CITY OF ALBUQUERQUE

PLANNING DEPARTMENT – Development Review Services

RE: **Weck's Restaurant – 730 Juan Tabo NE**
Drainage and Grading Plan
Engineer's Stamp Date 11-2-2015 (File: K22D006A)

Sheet Title
GRADING PLAN

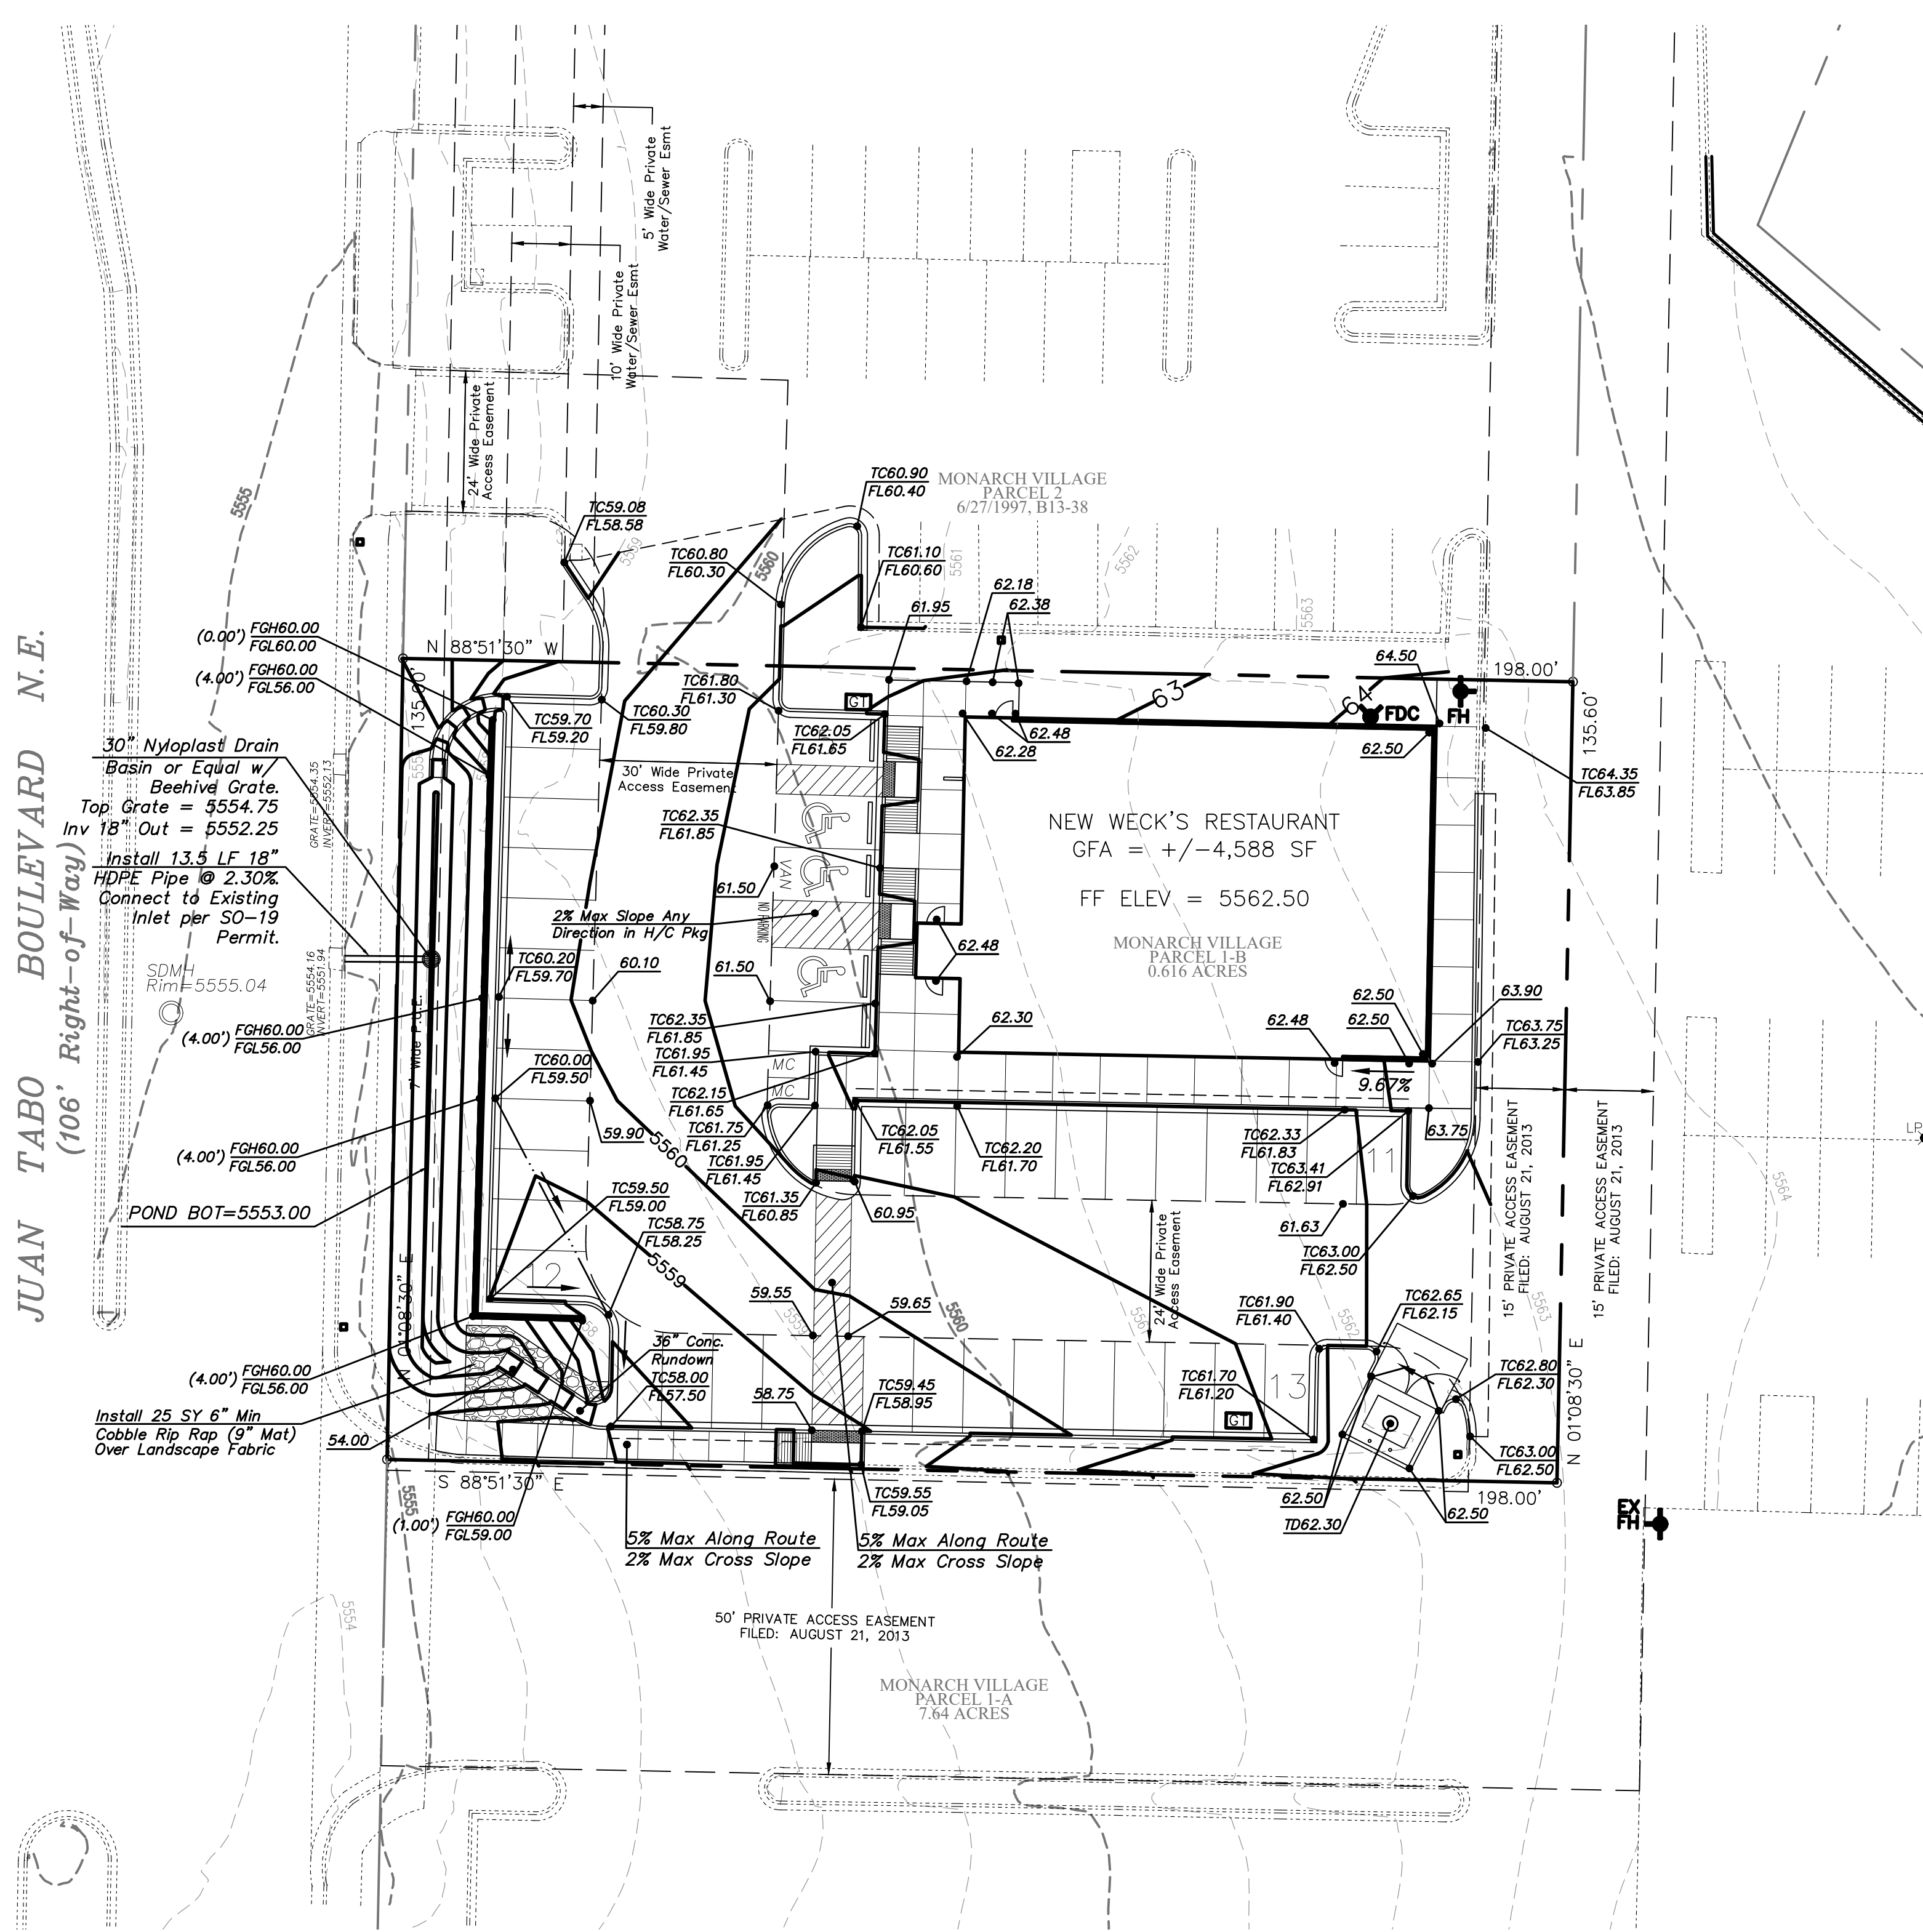
2. The pond is proposed within a 7-foot public utility easement. Are there utilities that will need to be lowered/relocated? If so, they will need to be fully coordinated prior to construction; a Certificate of Occupancy will not be issued if the pond volume is reduced during construction.

3. There is a 9.67% grade label shown that appears to be a typo along the southern sidewalk next to the building.
4. The calculation of the water harvesting pond volume appears to be overestimated. If the inlet opening is set at elevation 54, the volume "provided" in the pond between contours 54 and 55 (969 cubic feet) is not harvested.

Pond Cross Section

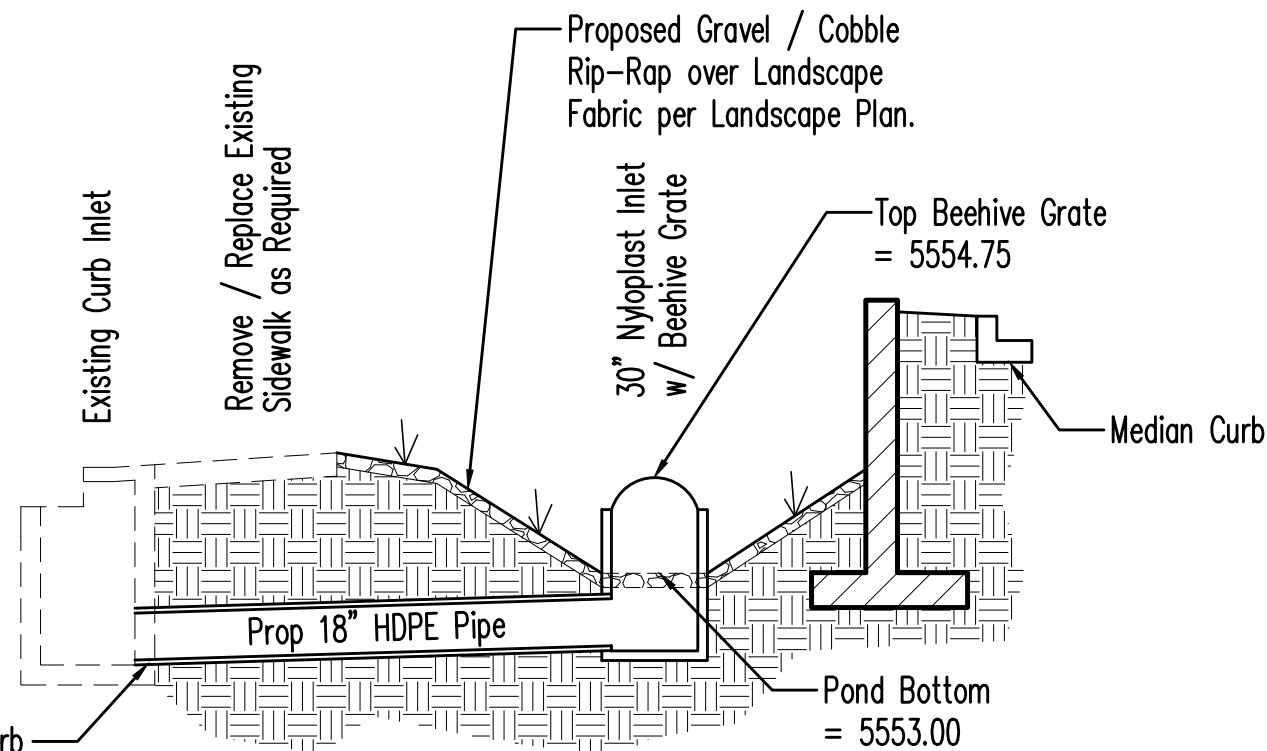
1. The outlet of the pond relies on 1-foot of head to discharge the 100-year, 13 cubic feet per second peak flow. The top of the proposed beehive grate is set at elevation 54.75. It is assumed that the "bottom" of the grate is set at 54.00 to ensure a head of 1-foot from the top of the pond which is set at 55.00. Otherwise, the height of the inlet needs to be adjusted.
